ADDENDUM NO. 1

PROJECT: **CARPET AND FLOORING FOR BOARD OF ELECTIONS
RENOVATION – PHASE 3**

**BOARD OF ELECTIONS
FURNITURE & FINISH PLAN - PHASE 3**

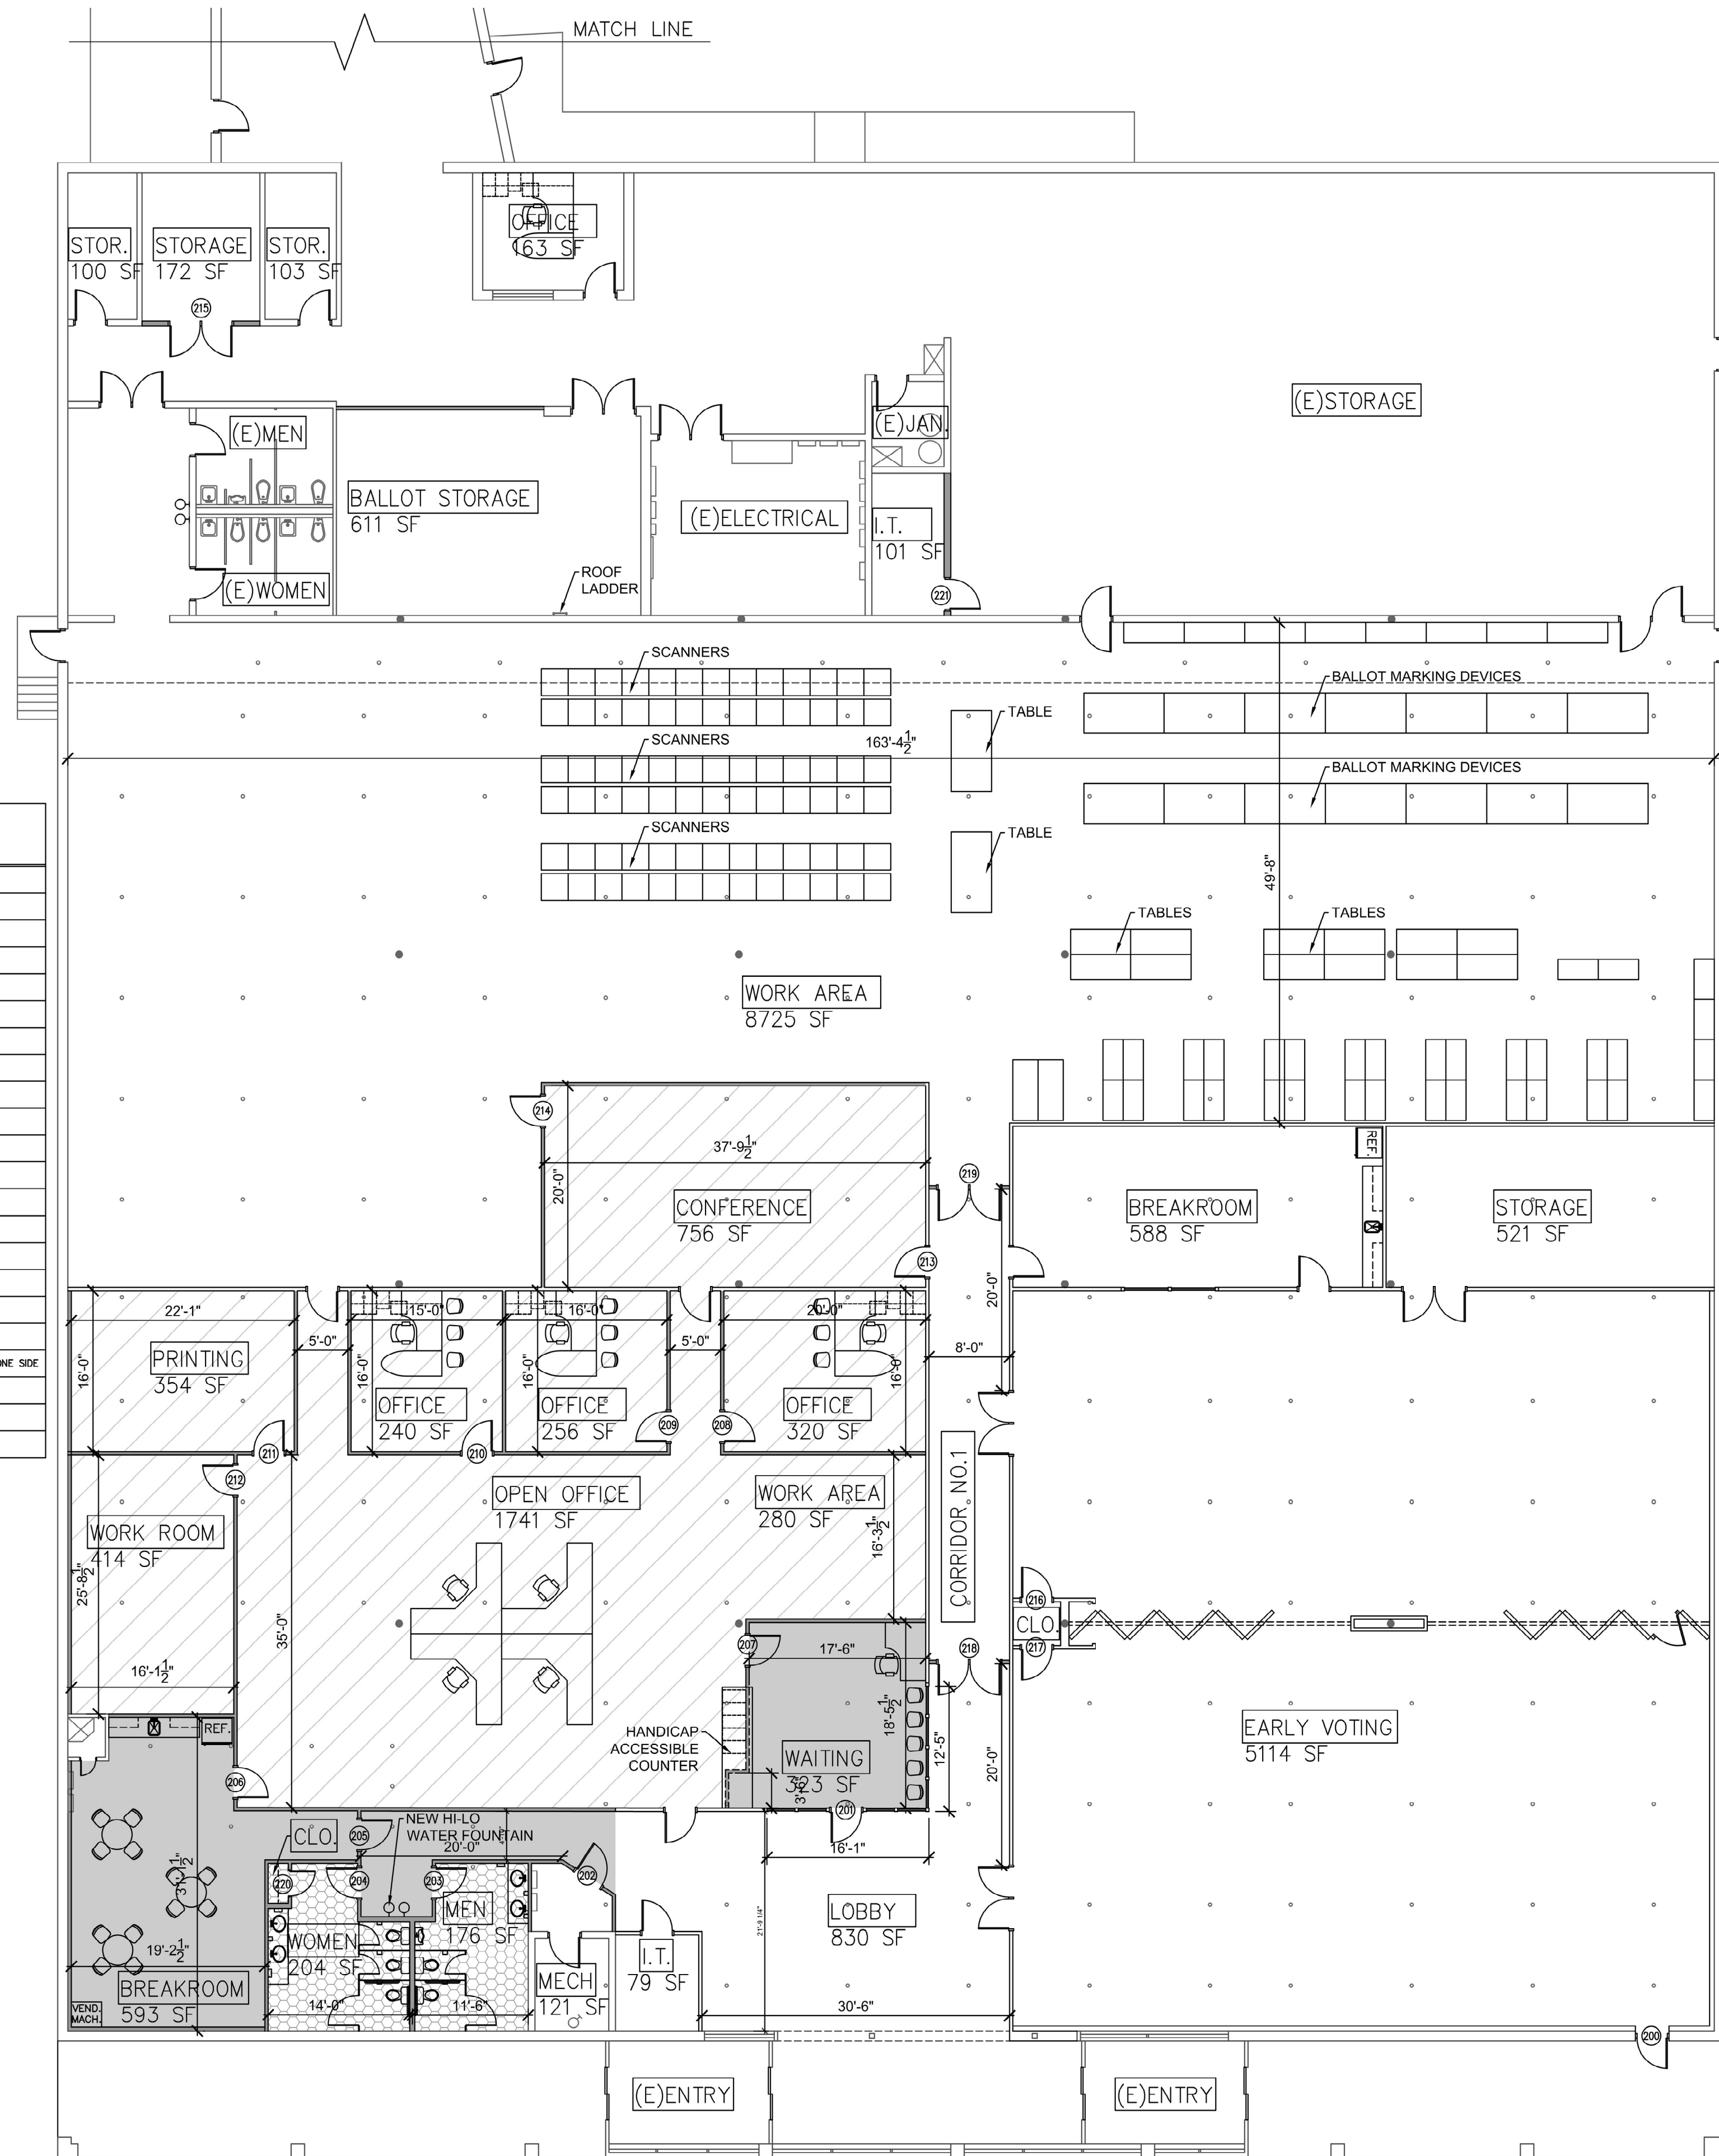
1. A revised Furniture and Finish Floor Plan has been issued to clarify the areas that are to receive carpet and porcelain floor tile. Please see attachment No. 1.
